P&A Procedure

EPIC Energy – Westland Park #2

San Juan Co, New Mexico, API #30-045-34750

Operator:	OGRID:
EPIC ENERGY, L.L.C.	372834
332 Road 3100	Action Number:
Aztec, NM 87410	364417
	Action Type:
	[C-103] NOI Plug & Abandon (C-103F)

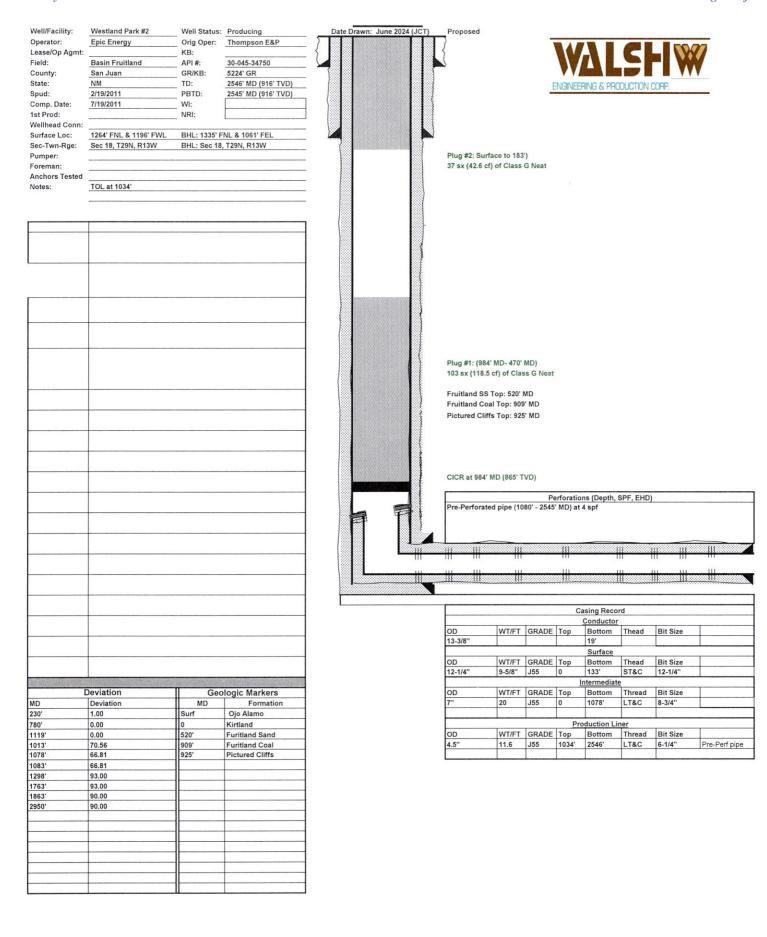
Created By	Condition	Condition Date
mkuehling	Notify NMOCD 24 hours prior to moving on - monitor string pressures daily report on subsequent - submit all logs prior to subsequent	9/23/2024
mkuehling	Log required	9/23/2024
mkuehling	The schematic shows an extra sting at surface which is a 13 3/8 pipe ran to 19 feet for boulders. please add the email from John Thompson dated 9/24/2024 to subsequent.	9/24/2024
